Design Refinement/Environmental Re-Evaluation Memo

**I-43: Brown Street to Capitol Drive
City of Milwaukee
Milwaukee County**

**Project ID: 1228-22-00
September 13, 2022**

Subject: I-43: Brown Street to Capitol Drive, Project Design ID: 1228-22-00

PROJECT NO: 1228-22-70 HWY: IH 43 COUNTY: MILWAUKEE PLAN DETAILS SHEET E

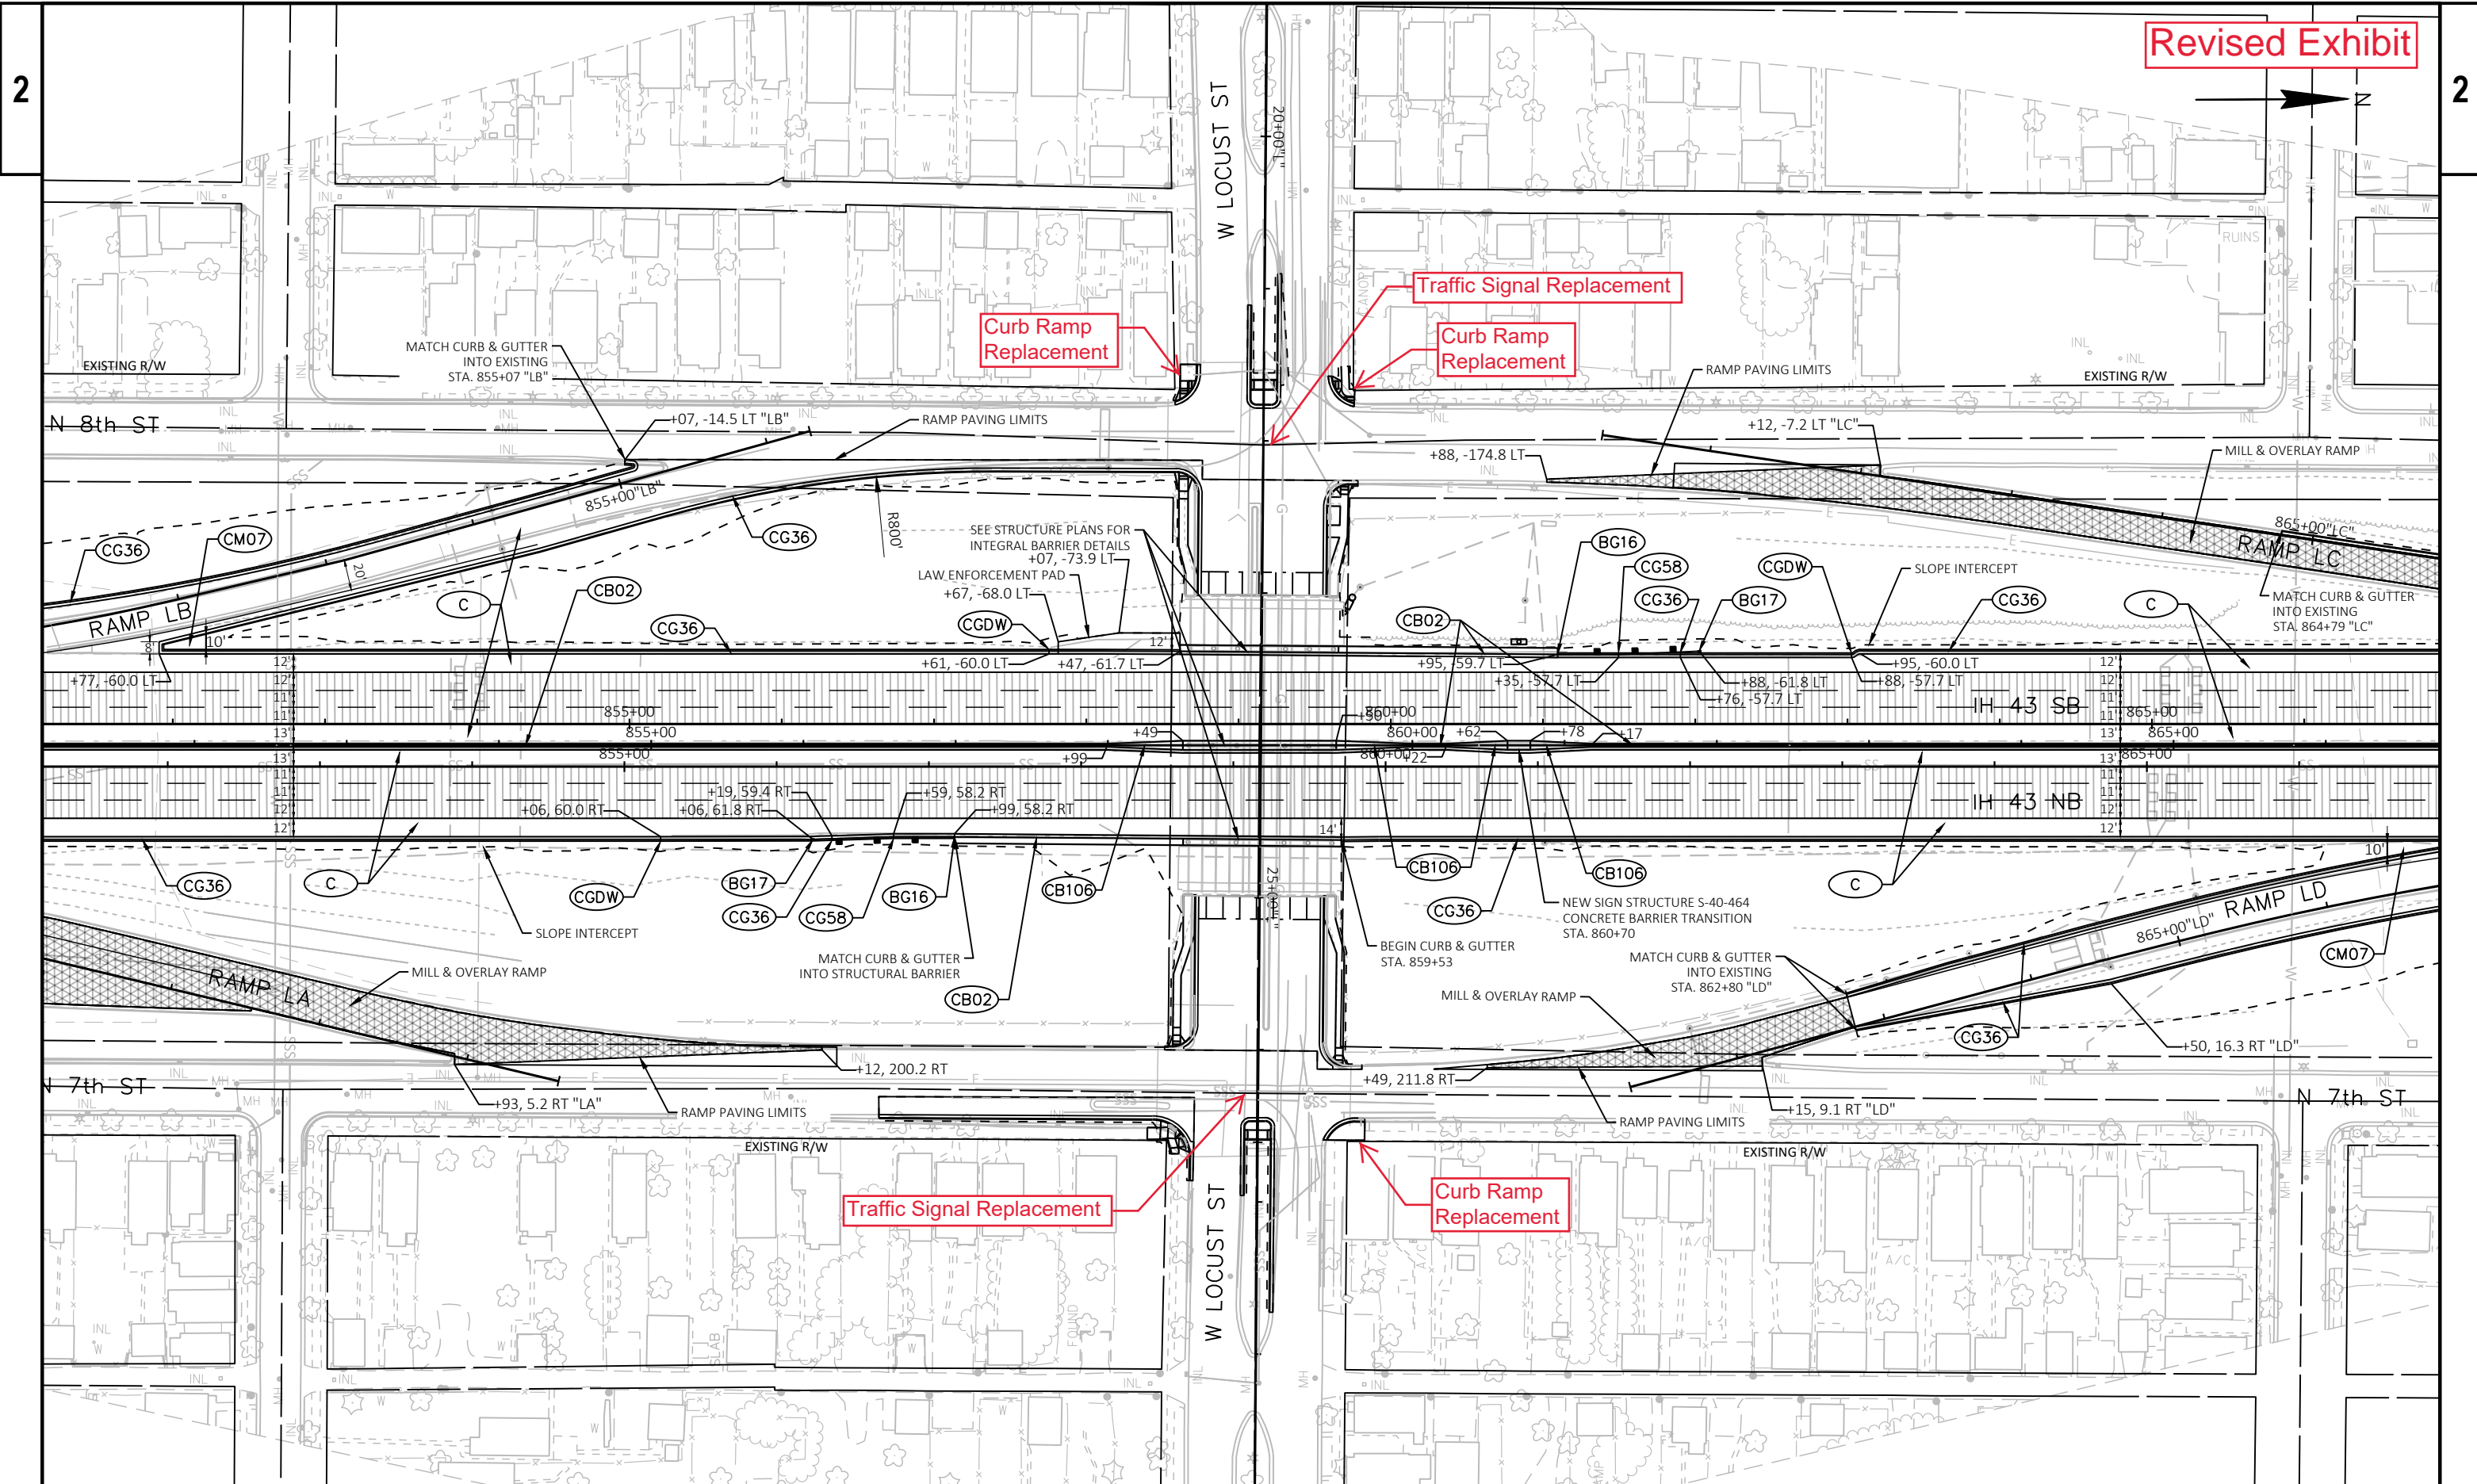
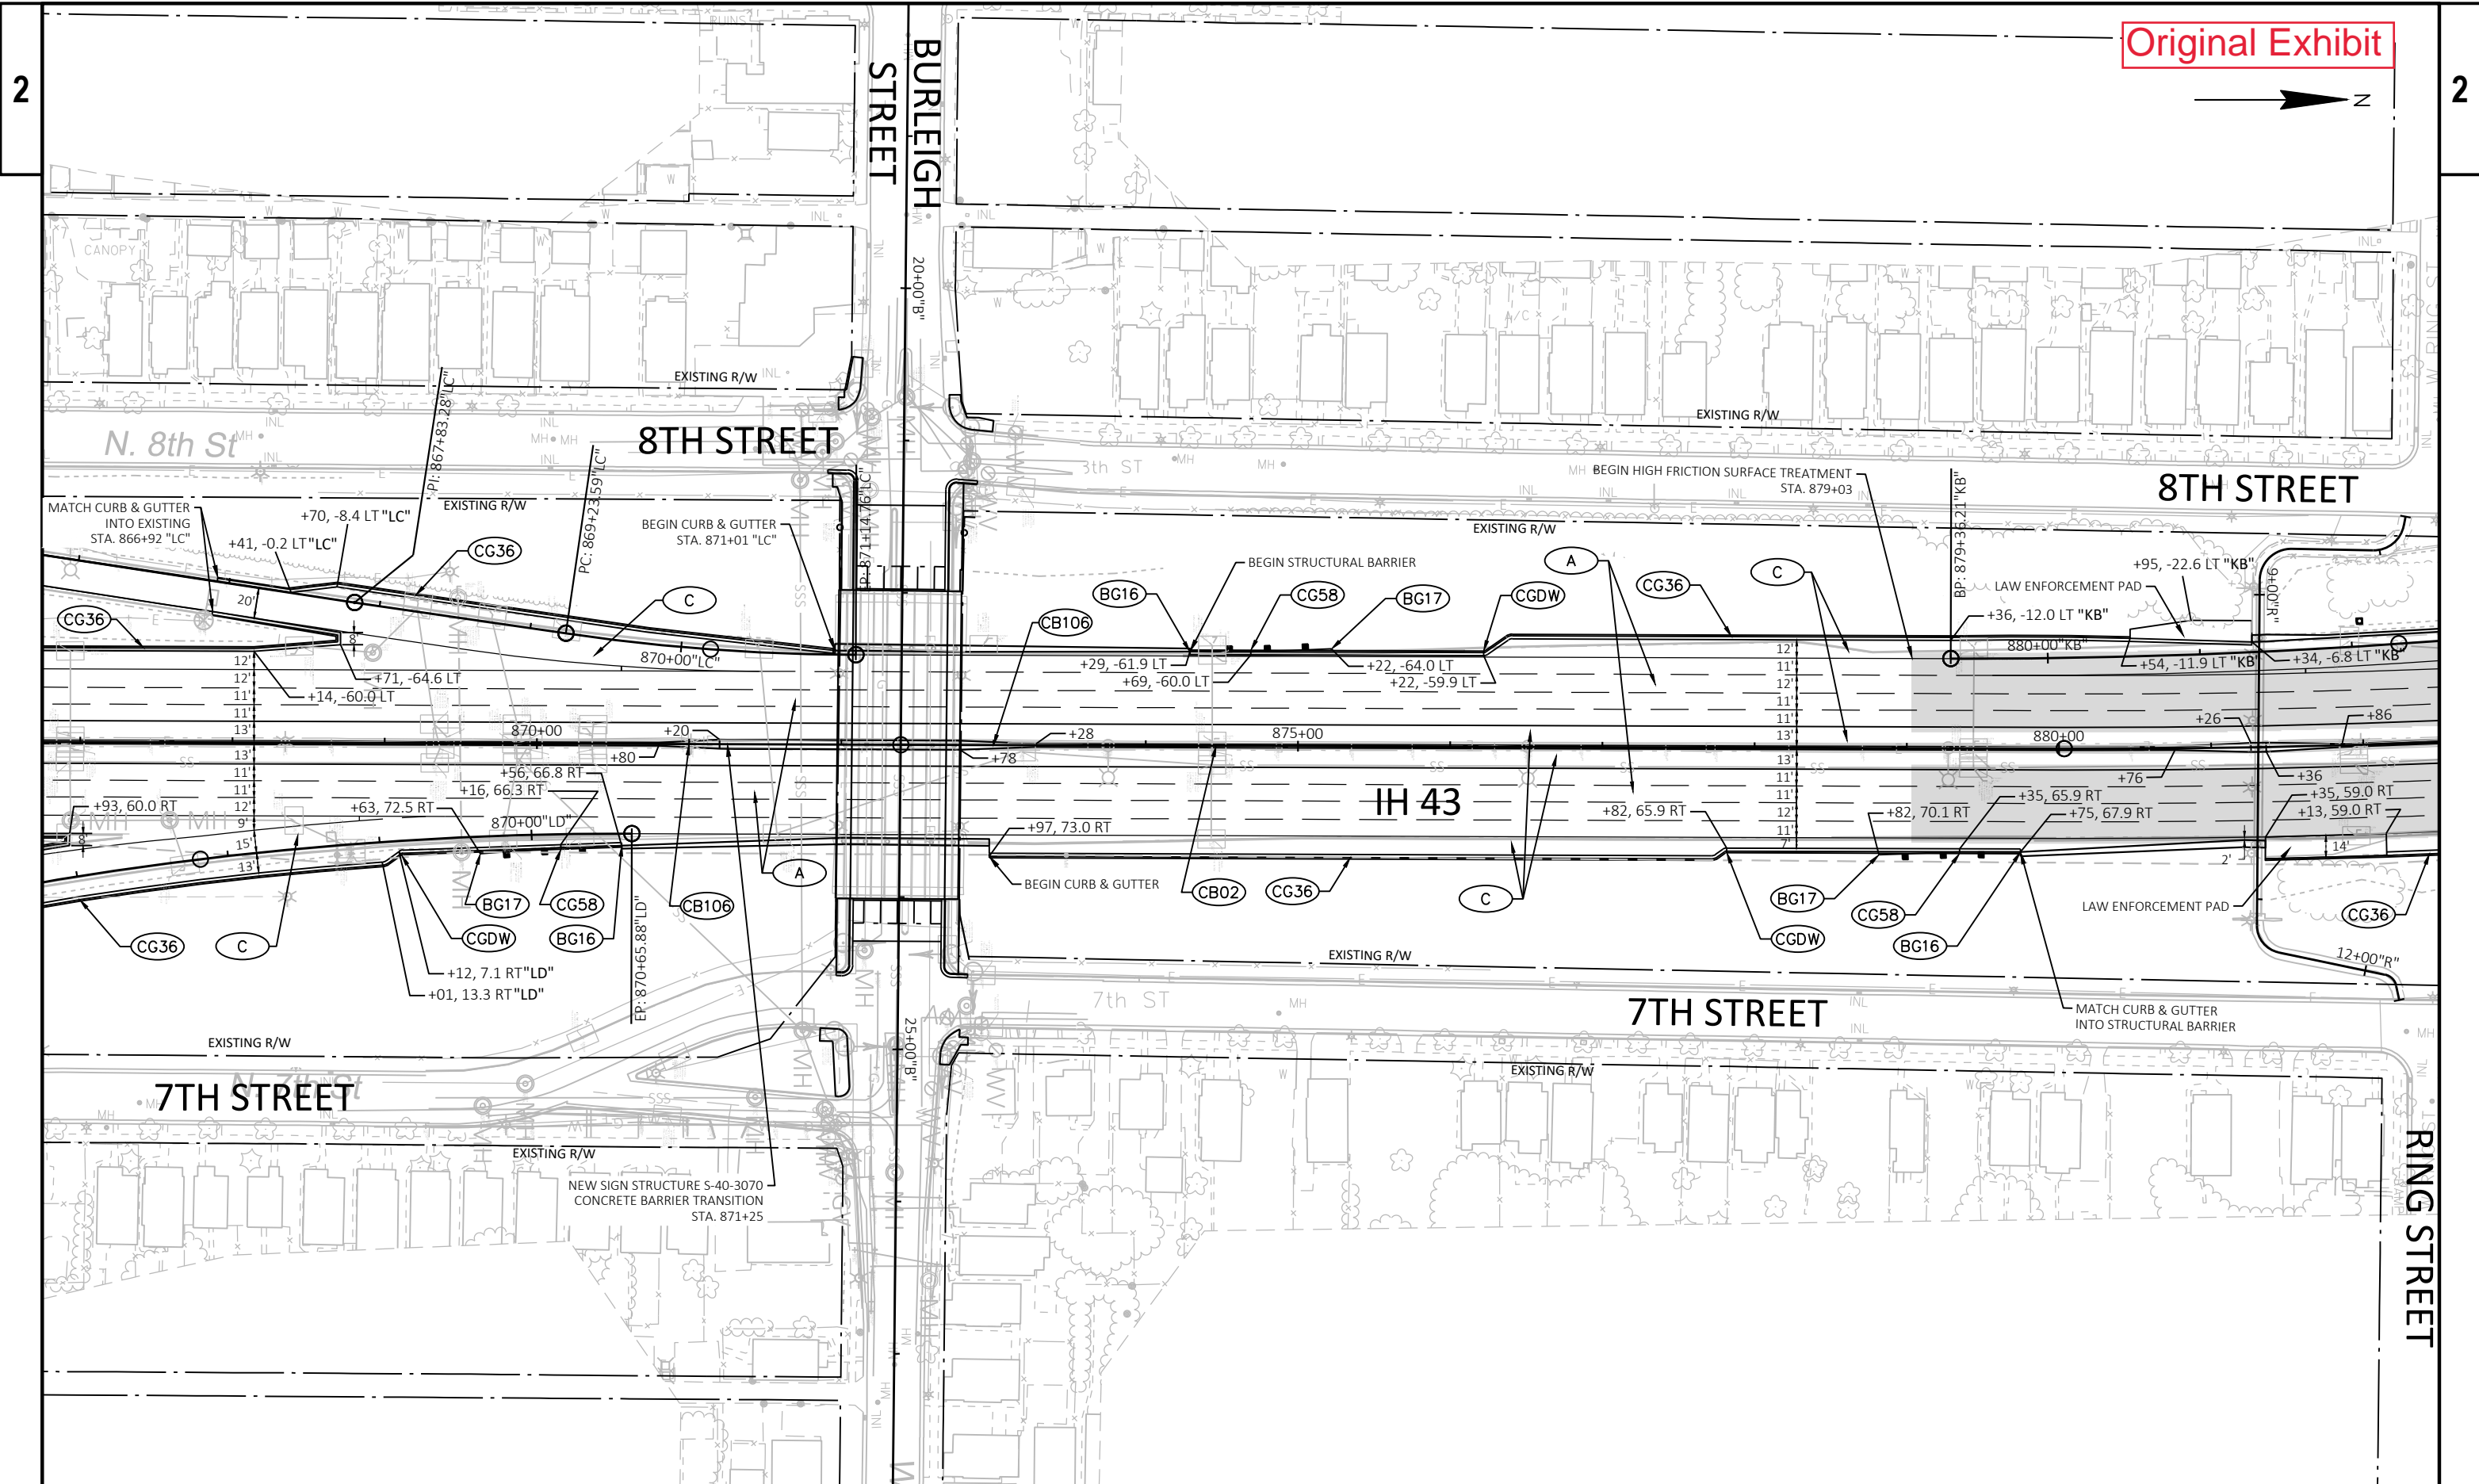
The original plan set overview sheet from the ER and a revised version with the complete scope are attached as Exhibit 1. More detailed plan sheets, consisting of the original provided in the Section 106 amendment and revised plan sheet, are attached in Exhibit 2.

Regarding the Section 106, the plan sheets in the original request for the project to be placed on the Screening List for archeology on September 11, 2020 include work within the subject intersections. Furthermore, the amended Section 106 plan sheets sent to Cultural Resources on February 21, 2022 further defines the intersection work.
